# Chennai Metro Rail Ltd

Prebid meeting-1

**Reference** : CMRL-PS&OHE-02-2016

**Contract name:** Design Manufacture, Supply, erection, testing and commissioning of 33kV shunt reactor for Power factor Correction along with required switchgears, cable, protections and SCADA interface at Receiving Substations of CMRL at Alandur

Chennai / D.0253 Overview Power Supply System		Drawing Title: OVERVIEW POWER SUPPLY SYSTEM	
A52811-B3223-S100		Drawing No.: OVERVIEW 33KV AUXILIARY NETWORK SINGLELINE DIAGRAM	
Prep: NTS	Check: Leaf/Prato	Appr: Schnick	Scale: 4 of 4
Drawn: .....	Date: .....	A52811-B3223-S100

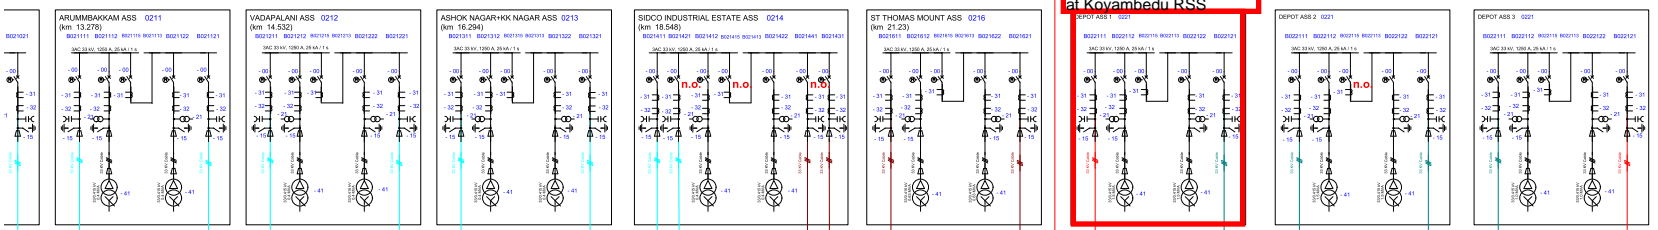
Reactor to be coupled here  
Physically located at Kovaybedu RSS
